U.S. Department of the Interior
BUREAU OF LAND MANAGEMENT

| Well Name: POKER LAKE UNIT 22 DTD | Well Location: T24S / R30E / SEC 22 / NWNW / | County or Parish/State: |

Notice of Intent

Type of Action: APD Change

WELL LOCATION AND ACREAGE DEDICATION PLAT

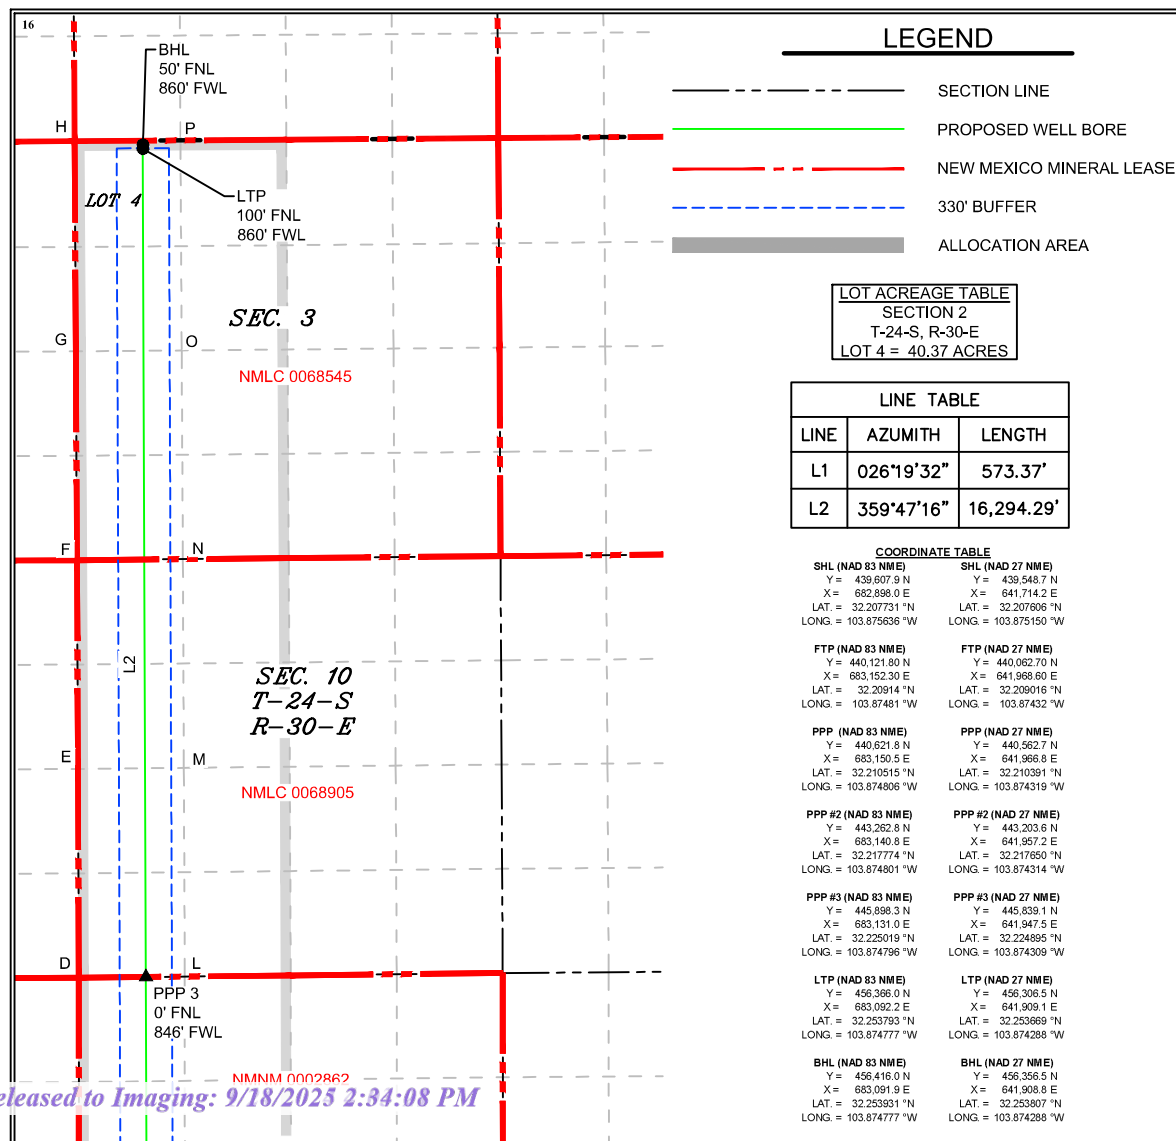
SHL: FROM: 1106 FNL & 115 FWL TO: 1011 FNL & 604 FWL of Section 22-T24S-R30E
BHL: FROM: 200 FNL & 754 FWL TO: 50 FNL & 860 FWL of Section 3-T24S-R30E
FTP: FROM: 100 FNL & 697 FWL TO: 500 FNL & 860 FWL of Section 22-T24S-R30E
LTP: FROM: 330 FNL & 753 FWL TO: 100 FNL & 860 FWL of Section 3-T24S-R30E

| UL or lot no. | Section | Township | Range | Lot Idn | Feet from the | North/South line | Feet from the | East/West line | County |
|---------------|-----------|------------|------------|---------|---------------|------------------|---------------|----------------|-------------|
| D | 22 | 24S | 30E | | 1,011 | NORTH | 604 | WEST | EDDY |

| UL or lot no. | Section | Township | Range | Lot Idn | Feet from the | North/South line | Feet from the | East/West line | County |
|---------------|----------|------------|------------|---------|---------------|------------------|---------------|----------------|-------------|
| 4 | 3 | 24S | 30E | | 50 | NORTH | 860 | WEST | EDDY |
